RECALL CAMPAIGNS

NAME OF MANUFACTURER : FERRARI

SUBJECT OF RECALL : FUEL SUPPLY/RETURN LINES

RECALL CAMPAIGN NUMBER : 98V-268

Fig. A

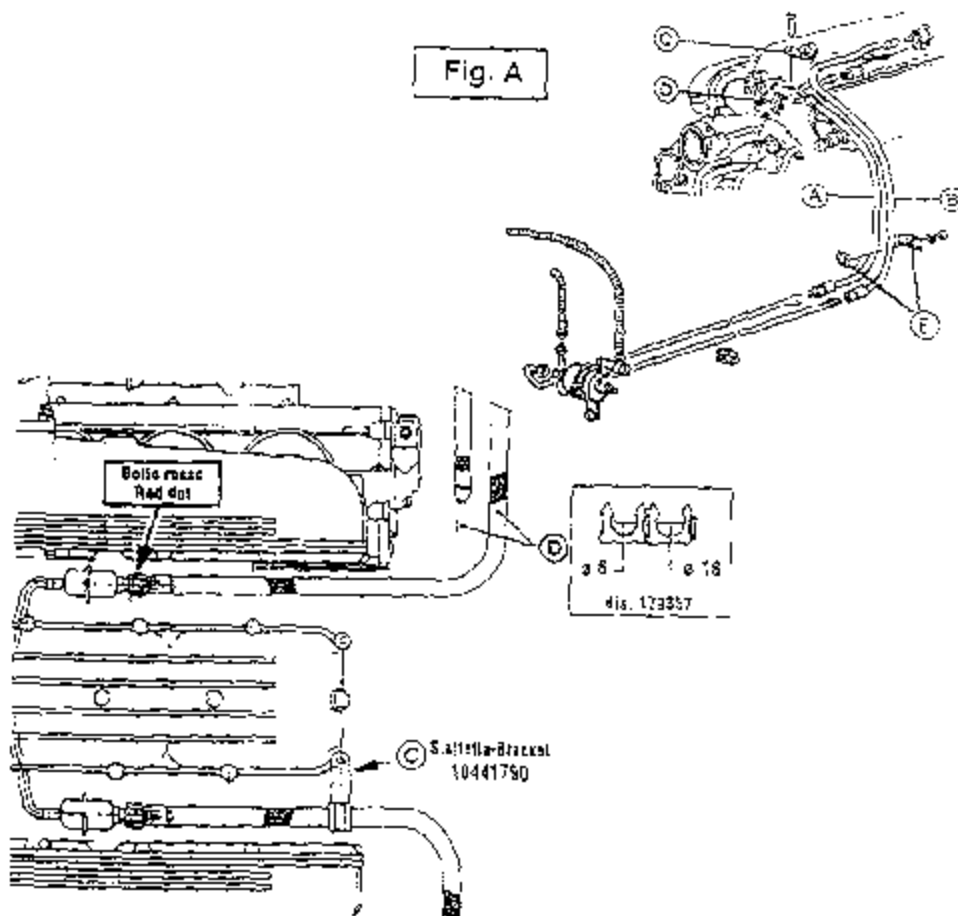
7) Release the supply and return hoses from their retaining clips.
(Item "E" in figure "A")

8) Remove the left side fuel lines
(Items "A" and "B" in figure "A")

9) Remove the right side fuel lines
(Items "A" and "B" in figure "A")

NOTE: THE NEW RETURN LINES (part numbers 179164 and 179356) HAVE BEEN MANUFACTURED IN A DIFFERENT SHAPE AND MUST BE ATTACHED TO THE CENTER INTAKE MANIFOLD USING THE NEW BRACKET (part number 10441790) ITEM "C" IN FIGURE "A"

12) Install the new retaining clips (part number 179357) item "D" in figure "A"

13) Reattach the supply and return hoses to their retaining clips.
(Item "E" in figure "A")

16) Identify updated vehicles with a dab of red paint applied to the union of the return line near the pressure regulator (see figure "A")

10) Install the new right side supply (part number 178525) and right side return (part number 179164) fuel lines tightening the unions to a torque of 2.5 Nm.

11) Install the new left side supply (part number 178522) and left side return (part number 179356) fuel lines tightening the unions to a torque of 2.5 Nm.

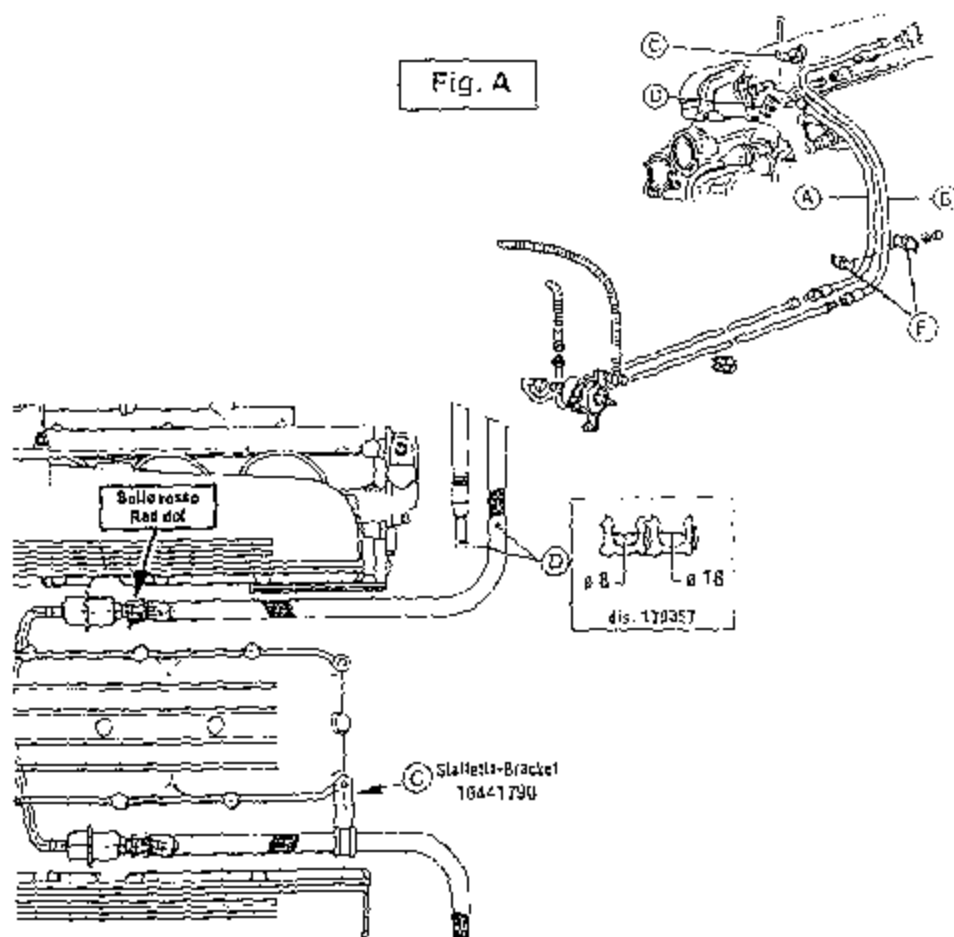
- 6) Remove front and center under panels
Remove the rear section of the front inner fender panels
- 7) Release the supply and return hoses from their retaining clips.
(Item "E" in figure "A")
- 8) Remove the left side fuel lines
(Items "A" and "B" in figure "A")
- 9) Remove the right side fuel lines
(Items "A" and "B" in figure "A")

NOTE: THE NEW RETURN LINES (part numbers 179164 and 179356) HAVE BEEN MANUFACTURED IN A DIFFERENT SHAPE AND MUST BE ATTACHED TO THE CENTER INTAKE MANIFOLD USING THE NEW BRACKET (part number 10441790) ITEM "C" IN FIGURE "A"

- 12) Install the new retaining clips (part number 179357) item "D" in figure "A"
- 13) Reattach the supply and return hoses to their retaining clips.
(Item "E" in figure "A") Do not over tighten
- 14) Reconnect the battery (main switch)
- 15) Replace the fuel tank fill cap

- 16) Identify updated vehicles with a dab of red paint applied to the union of the return line near the pressure regulator (see figure "A")
- 17) Reinstall the rear section of the front inner fender panels
- 18) Reinstall front and center under panels
- 19) Reinstall the front wheels and lower vehicle.

- 10) Install the new right side supply (part number 178525) and right side return (part number 179164) fuel lines tightening the unions to a torque of 34 Nm.(25 lb.ft.)
- 11) Install the new left side supply (part number 178522) and left side return (part number 179356) fuel lines tightening the unions to a torque of 34 Nm.(25 lb.ft.)
